# TECHNICAL SERVICE INFORMATION

Date: September 2000

| <b>MODEL</b>   | ALL MODELS WITH TRIM SENDER                          |
| <b>SUBJECT</b> | CHANGES TO TRIM SENDER AND TRIM METER SPECIFICATIONS |

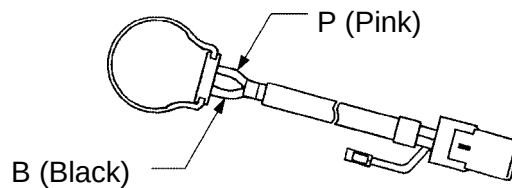
The trim sender and the trim meter have been changed from the three-wire to the two-wire type. No changes have been made to the connecting wire leads.

Trim sender

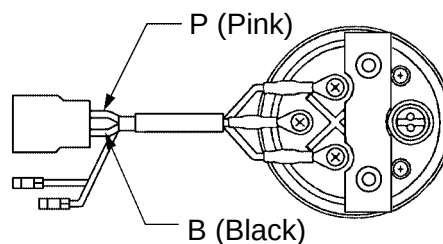
Both the trim sender and the trim meter can be identified by the number of their wires.

Previous: three-wire type – B (black), P (pink), O (orange)

New: two-wire type – B (black), P (pink)

The analog trim meter has been made more compact, with its depth made approximately 30 mm shorter than the previous meter.

## Digital tachometer

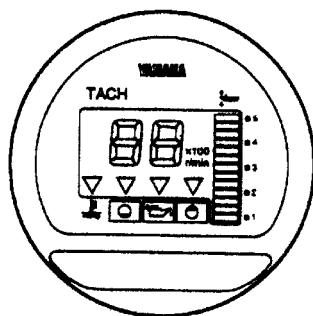
The digital tachometer (6Y5-83500-T2) that has been introduced with the year 2000 models supports both the two-wire and the three-wire type. The type of the sensor is selected at the switch located on the back of the meter.

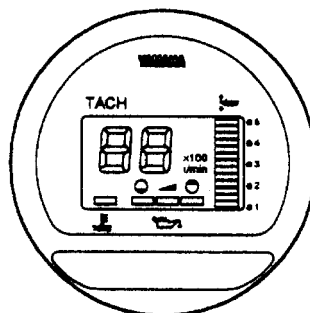
'99 6Y5-83500-T1  
Previous

'00 6Y5-83500-T2  
New

The design of the oil level display has been changed.

Switch 1 selection:  
ON (up) for two-wire type  
OFF (down) for three-wire type
